MEMORANDUM

REVIEW TYPE: **Major Amendment to Site Plan**  
CASE #: **82002036B**  
PROJECT NAME: Greenway Village at Clarksburg—Phases 1 and 2

APPLYING FOR: Approval to: 1) add development standards for building heights and setbacks; 2) modify street designs to respond to Fire and Rescue Service requirements; 3) revise conditions of approval for construction of the pool complex; 4) relocate a mailbox cluster; 5) modify grading for a stormwater management outfall; 6) add an optional retaining wall to a single lot; 7) revise the types of playground equipment provided at a single multi-age play area; 8) modify grading for a stormwater management facility in Block A; 9) change the timing for the completion of the bikepath along Skylark Road and 10) modify the location and width of the bikepath on Persimmon Ridge Road

### *Pool Complex*

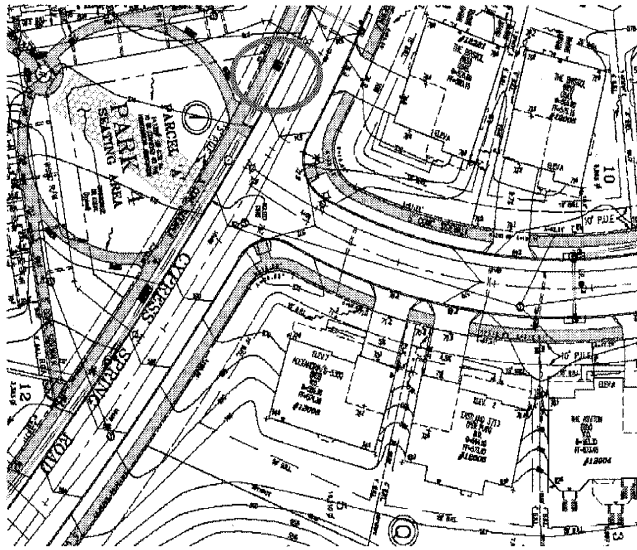
A previous amendment to this site plan (82002036A) revised the design of a planned pool house to include 2,000 square feet of community space. The approval conditions included a requirement that the pool house be completed before the earlier of two events: the achievement of 85 percent occupancy in phases 1 and 2, or June 1, 2006. Delays in approving the opinion and certified site plan for the amendment made it impossible to meet either of these timing requirements. This amendment would require the applicant to complete the pool/clubhouse within nine months of the issuance of a building permit for the project by the Department of Permitting Services.

- a. The proposed pool house and community center complex in Park 3 shall be completed within nine months of the issuance of a building permit for the complex by the Department of Permitting Services;
- b. The bike path required along the south side of Skylark Road must be completed concurrently with improvements to Skylark Road undertaken by the Department of Public Works and Transportation.

### *Modified Stormwater Management Outfall*

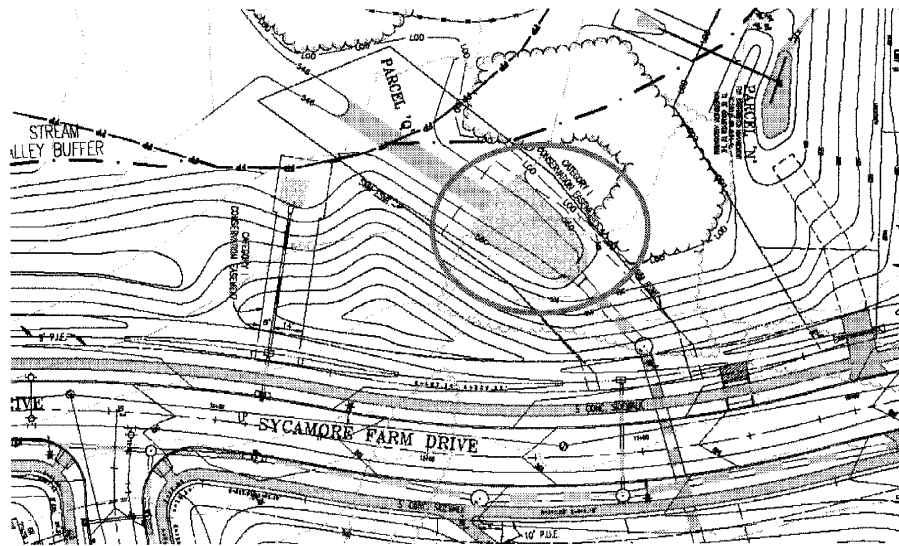
Detailed design of the stormwater management system adjacent to the pool complex requires extending the length of the outfall that will convey water to the stream that will accept the filtered

stormwater. Extending the length of the outfall requires revised land grading in the area of the outfall. The applicant proposes to alter the grading as part of this amendment. Environmental Planning staff has reviewed this proposal and recommends its approval.

### *Addition of Retaining Wall*

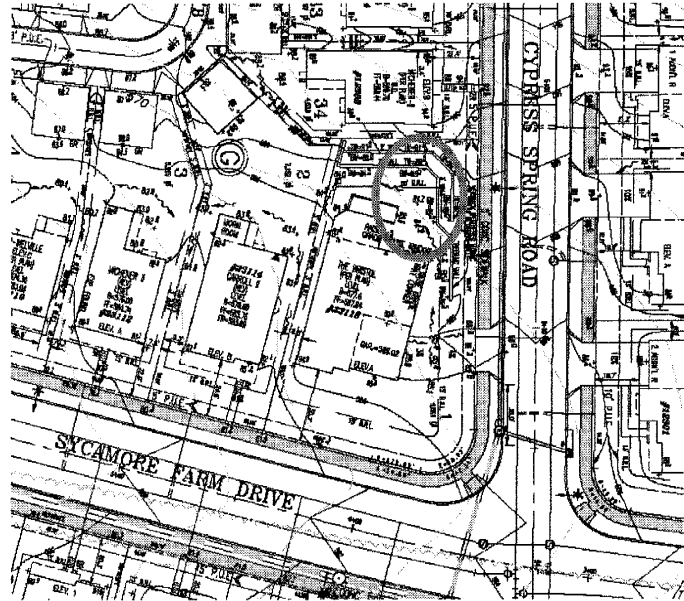
During field grading of Lot 1, Block G at the corner of Cypress Spring Road and Sycamore Farm Drive, the house's basement was located at a lower elevation than originally planned. The applicant proposes to allow correction of the difference in elevation by constructing a retaining wall, if desired by a future homeowner, in the portion of the lot nearest Lot 34, Block G, which is immediately adjacent on Cypress Spring Road.
